# **ASM FACILITY SITE PLAN**

**SP# 13-22 (FOLLOW UP TO MSP# 03-22)**

## **STAFF REPORT #2**

November 30, 2022

**C301**

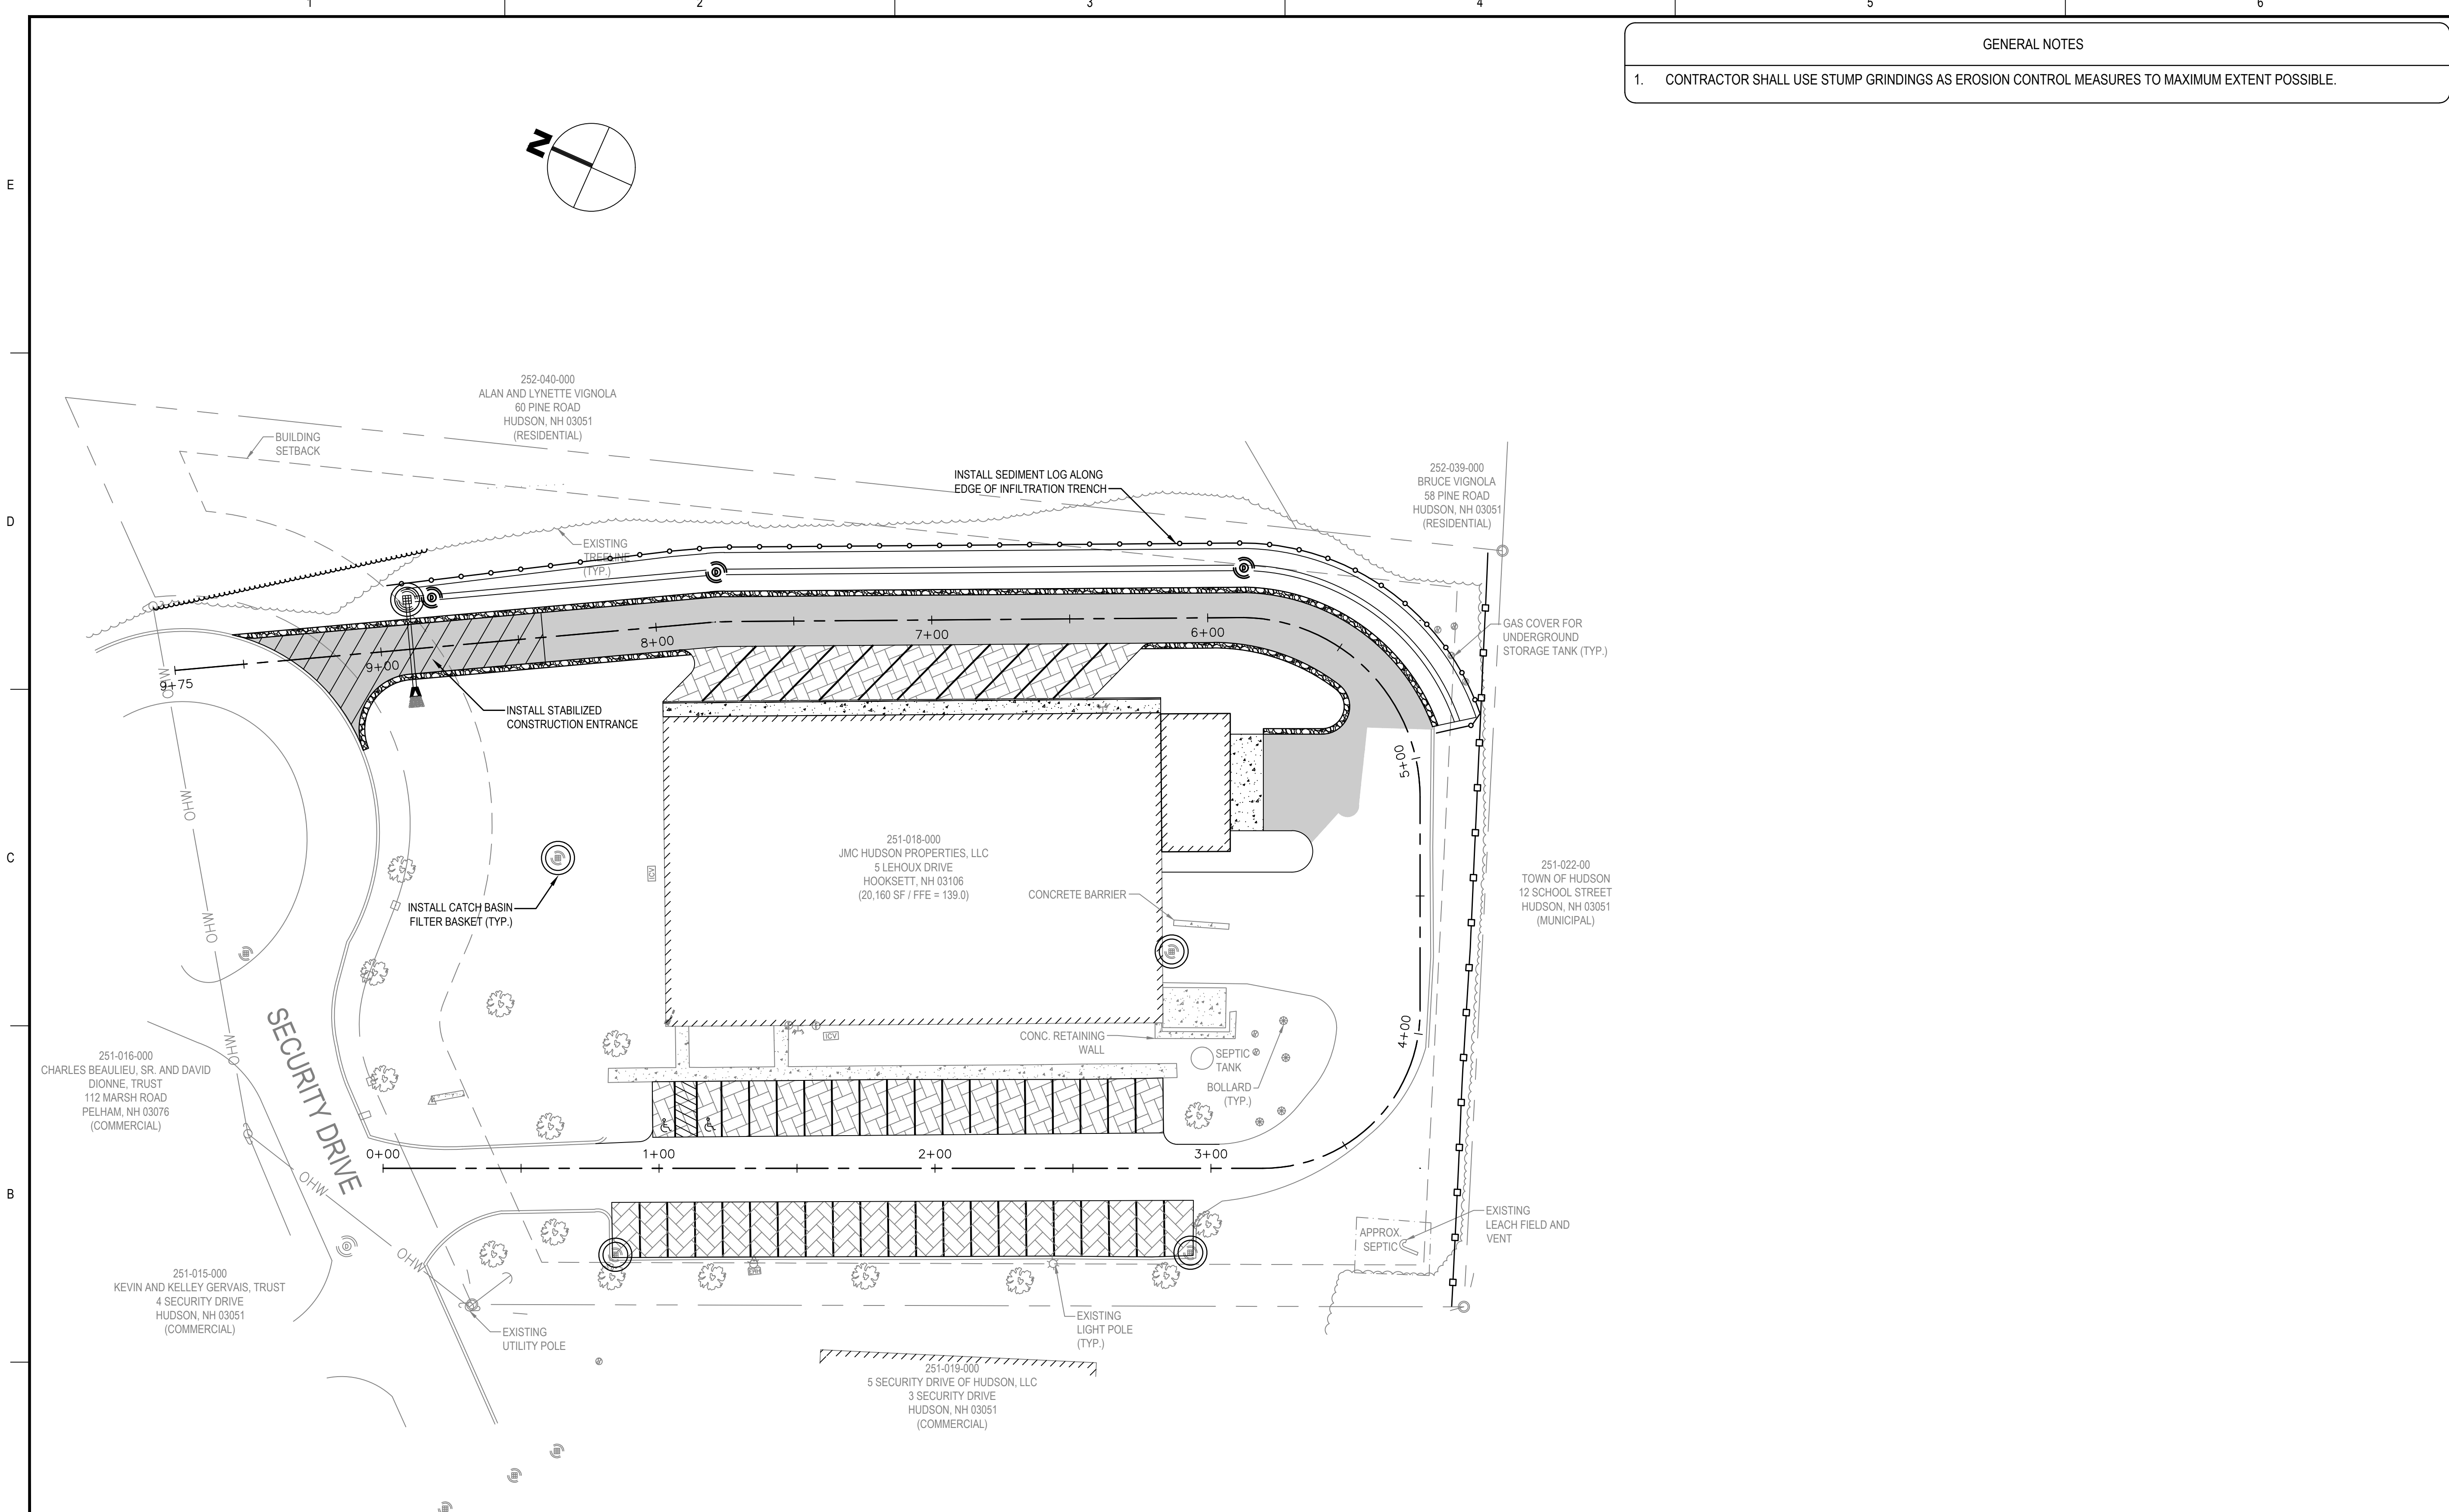
- o. SMR 290-5.B.1.b. The applicant should provide the required TSS and TP removal calculations for the proposed stormwater treatment.
- p. SMR 290-6.A.1. The applicant should add notes on the Erosion Control Plan Sheet C301 calling out the locations for the proposed Catch Basin Filter Baskets.

- p. SMR 290-6.A.1. The Applicant should add notes on the Erosion Control Plan Sheet C301 calling out the locations for the proposed Catch Basin Filter Baskets.**  
Done.
